Berkshire Pointe JSP13-47 with Rezoning 18.704

Public hearing of the request of Ivanhoe Companies for Planning Commission's recommendation to City Council for rezoning of property in Section 18, on the west side of Wixom Road, south of Grand River Avenue from B-2, Community Business and I-2, General Industrial to RM-1, Low Density, Low-Rise Multiple-Family Residential with a Planned Rezoning Overlay. The subject property is approximately 29.20 acres.

PLAN REVIEW CENTER REPORT

JSP13-47 Rezoning 18.704 with a PRO

ELEVATION A

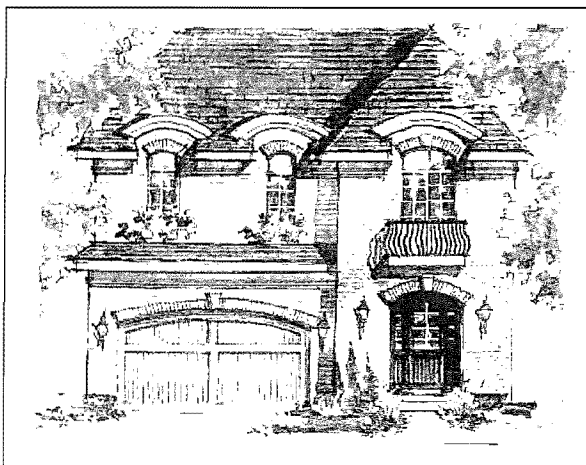
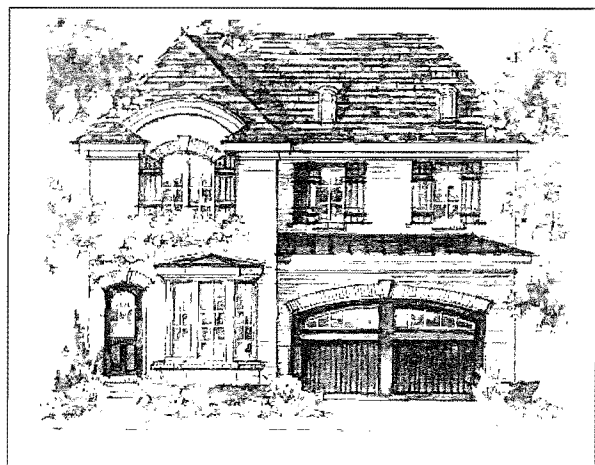
With respect to Section 303.2, all nearby homes (two on the left, two on the right and any across the street that overlap by 50%) must not be “substantially similar” in appearance to the proposed home. Specific criteria for compliance can be found in the Ordinance. The applicant has provided four renderings, all of which appear to be derived from the same or similar floor plans. End-to-end reversal is not considered a dissimilarity. Therefore elevations C & D would be considered “substantially similar” under this section. Only 3 of the elevations provided would be considered dissimilar. It is our experience that compliance with the Similar / Dissimilar Ordinance typically requires a minimum of 5 dissimilar facades or models within a given development. Considering the specific layout of this site plan, as many as 10 elevations may be included in the comparison for a given units (for example unit 82). For this reason and to account for uneven sales popularity and to allow greater flexibility, a greater number of elevations would be desirable. We believe that compliance with the Similar / Dissimilar Ordinance could not be achieved given the quantity of models provided. It is recommended that the applicant provide additional facade examples to more adequately demonstrate how compliance with Section 303.2 will be achieved.

sheet title:
**detached single family
 concept site plan**

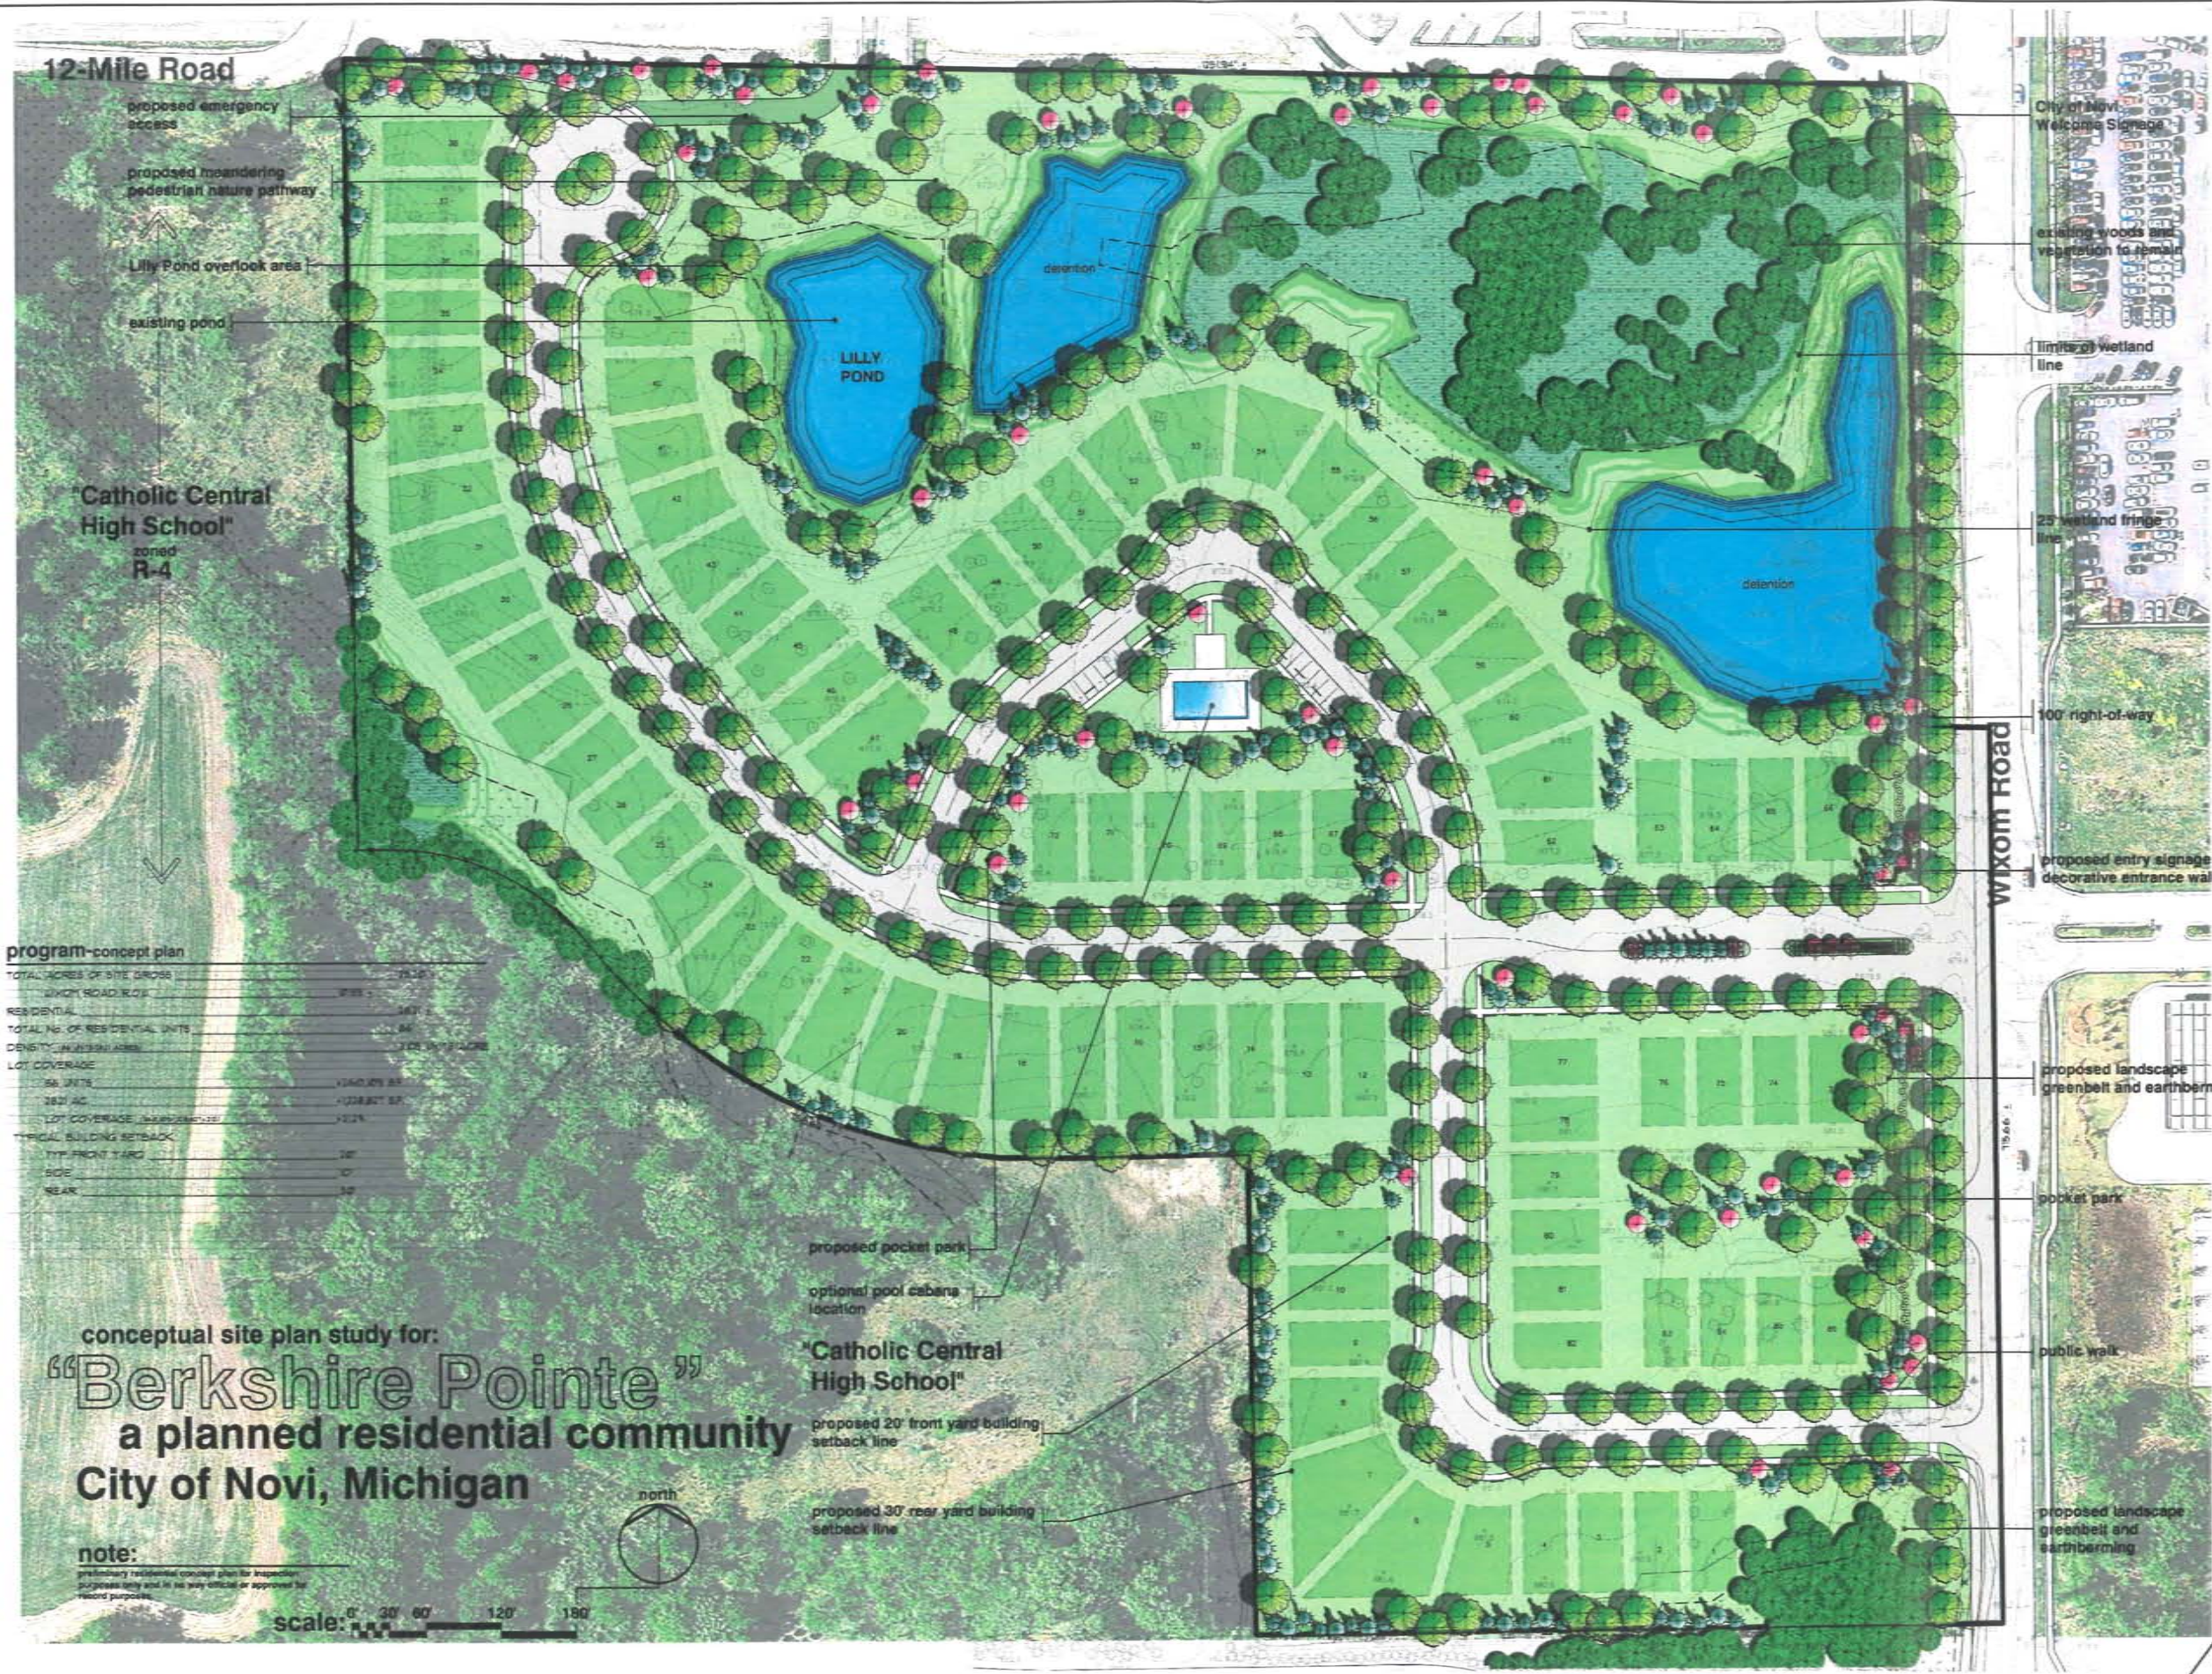
4. Revise the site plan to indicate whether the proposed roads are private or will be publically dedicated.
5. Provide a stub street to the subdivision boundary for every 1,300 feet of perimeter or include a separate narrative listing the hardships/impracticalities of extending the streets to the subdivision boundaries at intervals along the subdivision boundary not exceeding one thousand three hundred (1,300) feet.

10. Add a note to the plan stating that the emergency access gate is to be installed and closed prior to the issuance of the first TCO in the subdivision.

16. Designate whether the Novi Nature Path will be a public pathway or part of the site condominium. If the pathway will be dedicated as public, revise the pathway material from wood chips to concrete.

- b. **Each one-way roadway scales 28 ft wide and will have to be reduced to no more than the 27-ft maximum permitted by DCS Figure IX.3 (24 ft is standard).**

- c. The easterly boulevard island scales 104 ft long and will have to be shortened to no more than the 100-ft maximum permitted by DCS Figure IX.3.
- d. The offset of the easterly boulevard island from Wixom Road will have to be both justified and waived by the Council if greater than the maximum of 18 ft permitted by DCS Figure IX.3.
- e. The island width should be narrowed to the City standard 10 feet in width. This will reduce the left turn conflict with the drive on the other side.

- 29. The Berkshire Drive cul-de-sac scales approximately 700 ft long, referenced to its west intersection with Berkshire Circle. This length is acceptable as it is 100 ft less than the City maximum. **The preliminary site plan should provide stationing or a dimension along the street centerline confirming this cul-de-sac length.**
